Islam Garments

Islam Knit Design

Zarun, Konabari, Gazipur, Dhaka
(+23.9955N, 90.3263E)

16 September 2013

Item 1 High Stress to Building internal columns

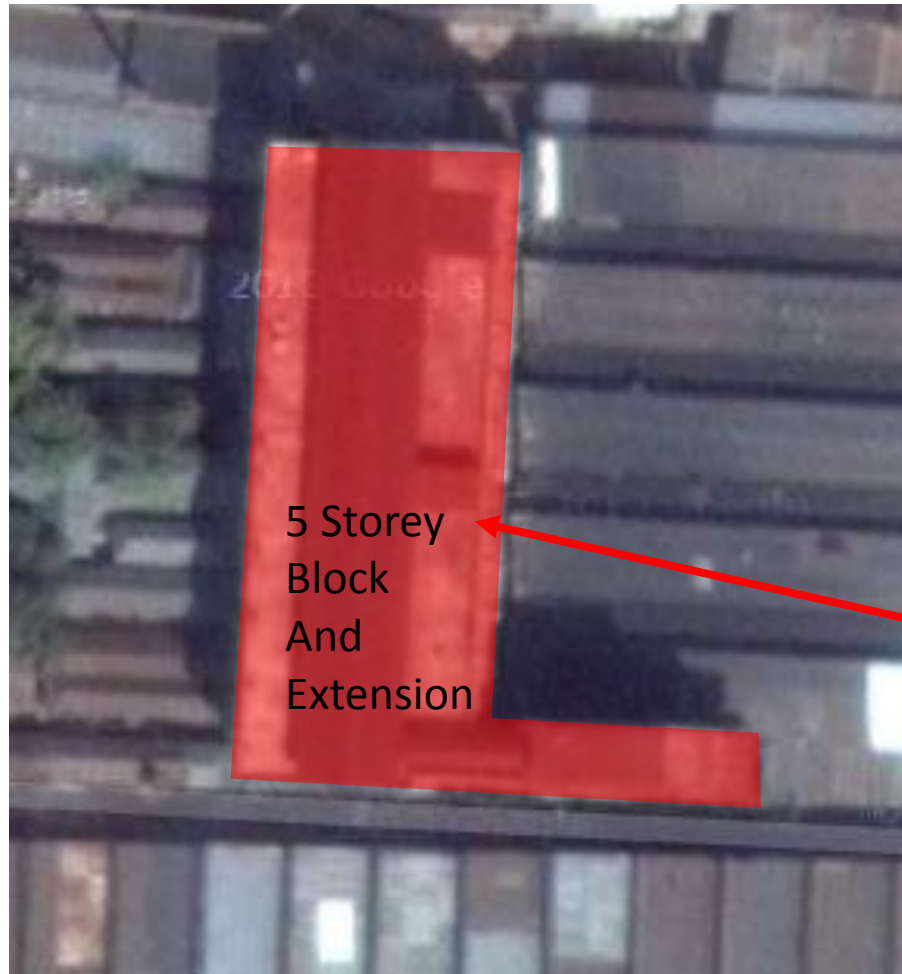
**Check on Column stress levels immediately
required to the 5 storey block**

Verify concrete strengths in internal columns and reduce loads

**Remove all personnel
from this building
until results of
columns strengths
and Building
Engineering
assessment is
complete**

Heavy water tank, not on design drawing.

Limited North-South stability, only pairs of columns, no in-fill walls

Water ingress causing corrosion to structure and facade

Steam rejection causing constant wetting and corrosion

Cracking in beam likely due to corrosion of rebar

Lightweight steel structure, not on permit plans

Roof drainage causing corrosion to structural masonry wall

Lightweight steel structures, not on permit plans, open to wind uplift

Inadequate tie-down details

**Interface large steel shed roof
and 10-storey building**

Lateral load from large steel shed roof is imposed on building columns between floor levels

Item 1 High Stress to Building internal columns

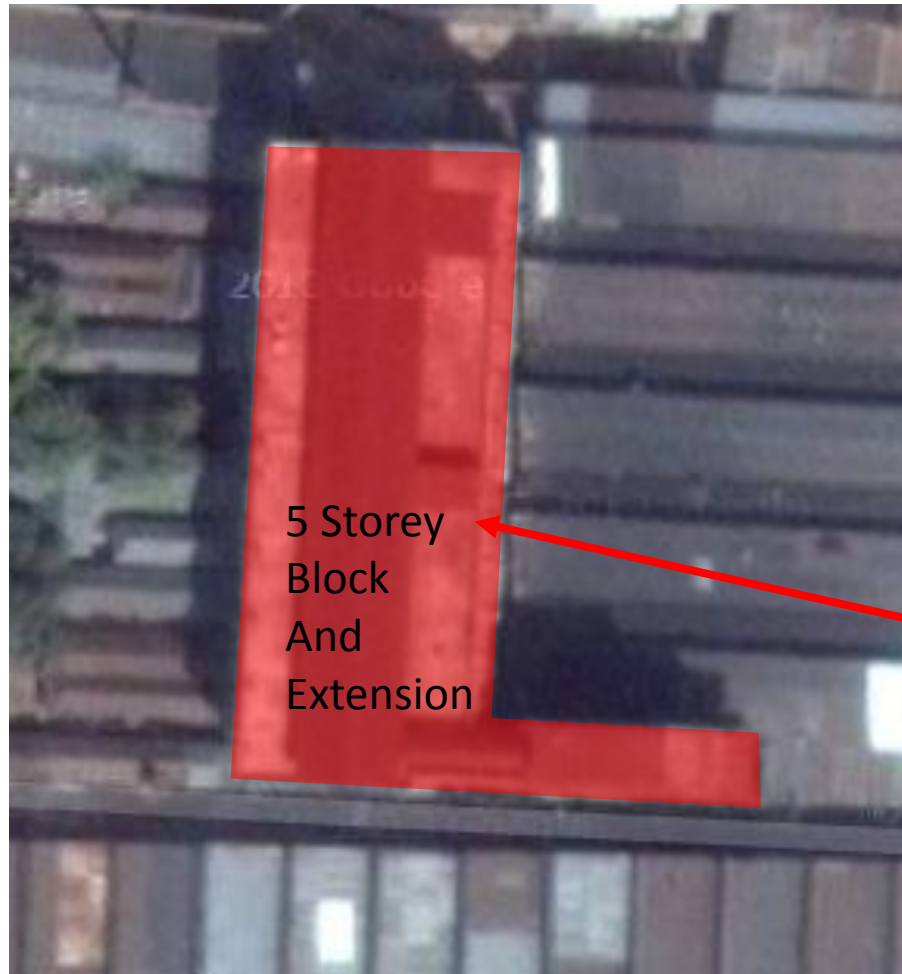
Verify concrete strengths in internal columns and reduce loads

Remove all personnel from this building until results of columns strengths and Building Engineering assessment is complete
